Boeing 767 and 777 Cargo door actuator

Boeing 767 and 777 Cargo Door Actuator

Affected units

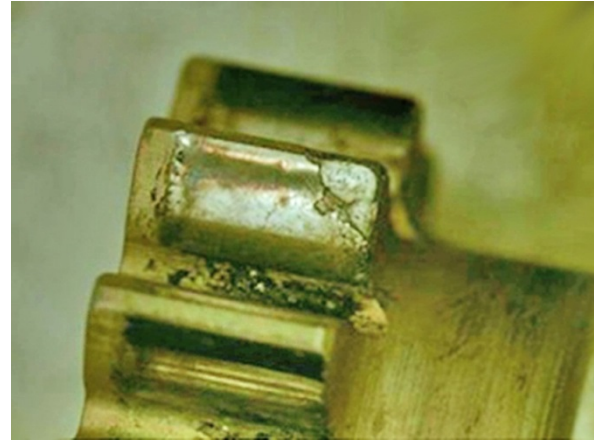
692D100-13 marked with no serial number suffix or suffix 'A'

Failure causes the lower lobe cargo door system to become inoperable with the potential for uncommanded door closure, causing a possible safety risk to ground personnel

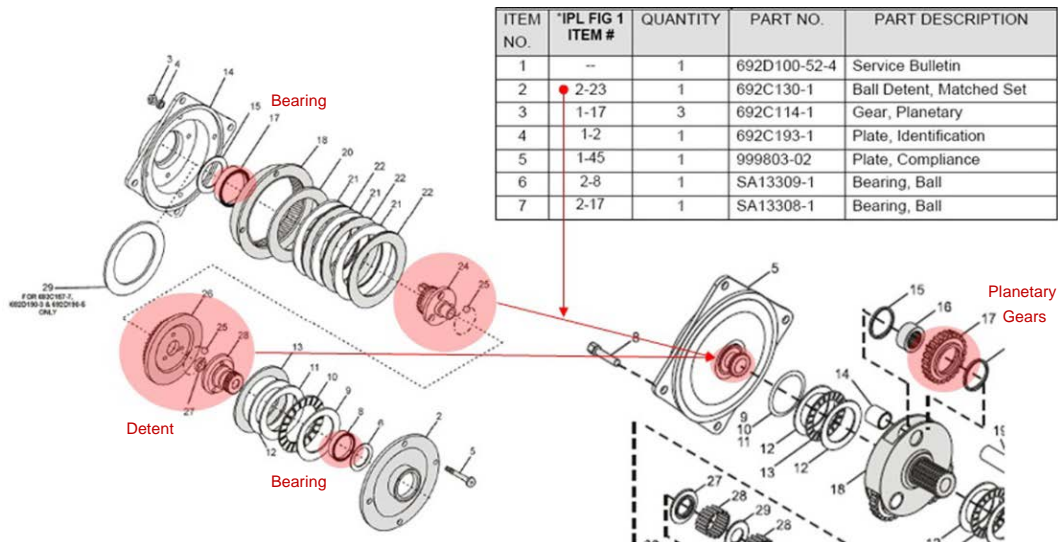
- Due to high operating loads, Nitralloy gears are susceptible to case crushing. Once the nitride case is compromised the cracks propagate causing gear failure.
- Gears made with carburized 9310 Steel are not as susceptible to case crushing failure mechanism

The 692D100-15 equipped with carburized 9310 steel detent assemblies has been approved and released

Repair services and parts required to implement SB692D100-52-4 are available now

If part number 692D190-5 (no back assembly) is purchased, then only items 3, 4 and 5 in the table below are required.
